**05-008/14 - MULTI-MODEL (6 SPEED SKYACTIV M/T) - HARD  
TO SHIFT INTO 3RD, 4TH, 5TH AND/OR 6TH GEAR**

| <b>Subject:</b><br><br>HARD TO SHIFT INTO 3RD, 4TH, 5TH AND/OR 6TH GEAR | <b>Bulletin No:</b> 05-008/14  |

- This bulletin supersedes the previous bulletins 05-008/14 issued on 07/14/14. The APPLICABLE MODELS, DESCRIPTION, REPAIR PROCEDURE, and WARRANTY INFORMATION have been revised.
- Changes are noted below beside the change bar in Red.

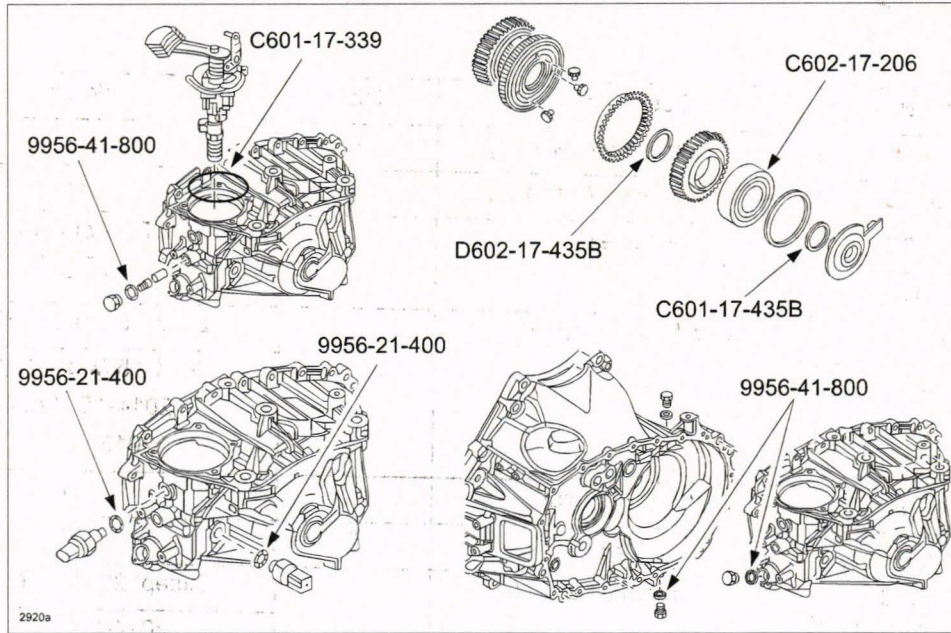
This is caused by a failure of the related clutch hub(s). To correct the problem of hard shifting, the shape of the 3-4 and 5-6 clutch hub has been changed. A surface treatment has now been added to the 3-4 clutch hub to prevent 3rd gear from jumping out.

1. Verify customer concern.
2. Remove the transaxle. Refer to MS3 online instructions or the Workshop Manual section 05-15.
3. Replace the 3-4 and 5-6 clutch hub with a modified one and the 3rd gear with a new one (listed in the Parts Information). Refer to the C66M-R 6-speed SKYACTIV Manual Transaxle Workshop Manual.

- Bearing Puller part number 4907-10-520-L is used for this repair.
  - If 3rd gear is jumping out, replace the 3rd gear with a new one.
4. Install the transaxle.
  5. Verify repair.
